Product Change Notification: PCN-22-156615

Deutsch DTM13 Family Housing Design Change

RE: DEUTSCH DTM Series 12 Pin -R019, -R008 MOD  
Puller Addition on Bottom Half

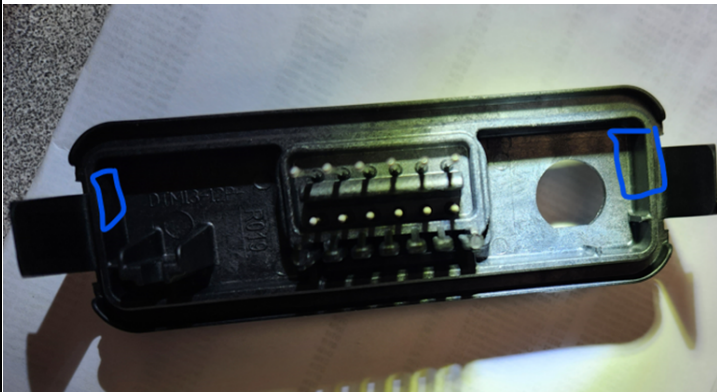
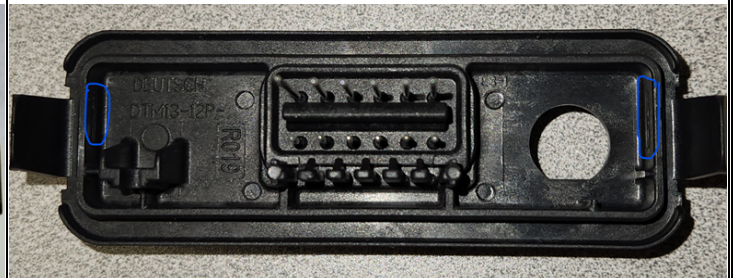
The Industrial and Commercial Transportation business unit of TE Connectivity is making a change to the design of a noncritical feature for the part number(s) listed below. These PNs are TE proprietary designs, therefore considered catalog/general market product. PPAP and/or sample requests must be submitted within 14 days of PCN submission via [ict-ppap-request@te.com](mailto:ict-ppap-request@te.com) or ePPAP system. Submission will not occur without request. If PPAP requested, disposition response is required within 14 days of submit date or it will be considered approved. Product drawing(s) are affected.

No Pullers

Pullers

No Pullers Full Part

With Pullers Full Part

Dear Customer, we hereby inform you of this change. The change is necessary to improve the molding process. The change does not impact performance. IMPORTANT: The current and previous revisions of these parts can be used interchangeably in the field. The change(s) are being phased in gradually and previous revision can remain stocked until use. Shipments of both configurations may be mixed.

Pictures below are for reference only.

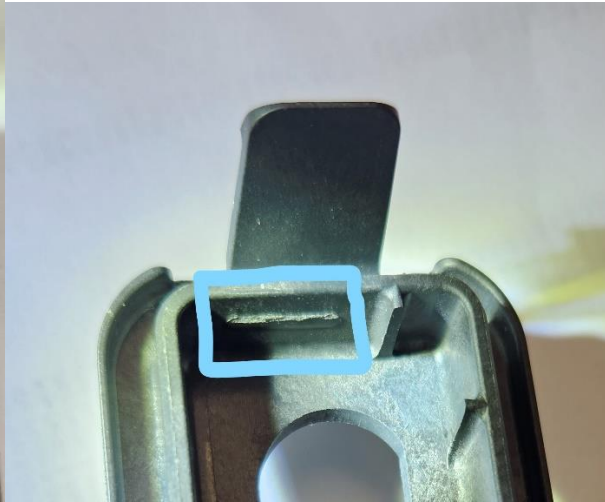
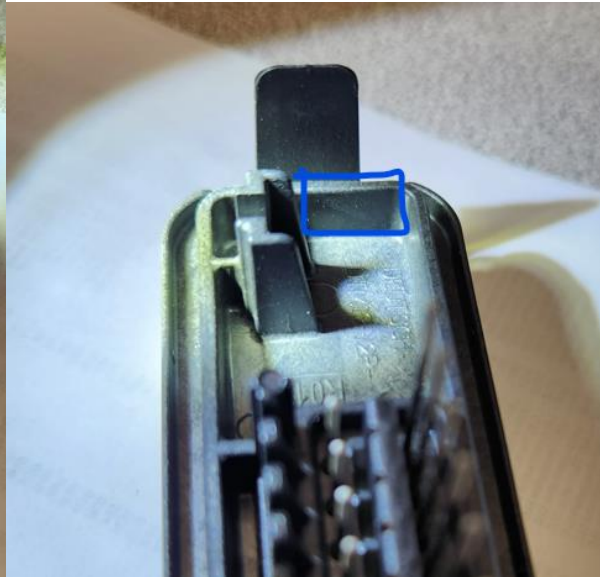
This letter is to inform you that due to issues during the ejection of parts from the mold, the Industrial and Commercial Transportation business unit of ("TE") Connectivity is requesting your approval of a deviation that allows TE to manufacture the DTM Series 12 Pin -R019 and -R008 MOD part numbers (affected part numbers appear below) with pullers to avoid parts sticking and crashing the mold.

NOTE: This is an appearance change only and does NOT affect fit or function.
